South Sausalito Proposed Improvements

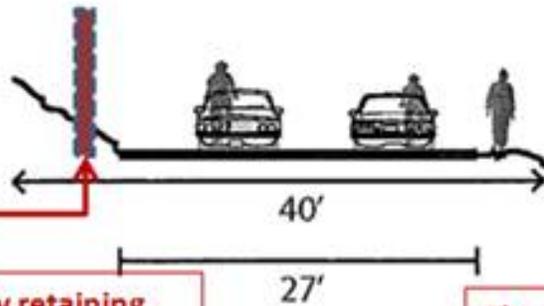
There are already retaining walls here- both on Marie's property and at the GGNRA-City property lines were there was a slide ~10 years ago.

This area is largely car parking on the GGNRA side. Removing parking here is a tough sell to neighbors with no garages. On the City side my neighbors house is in this location
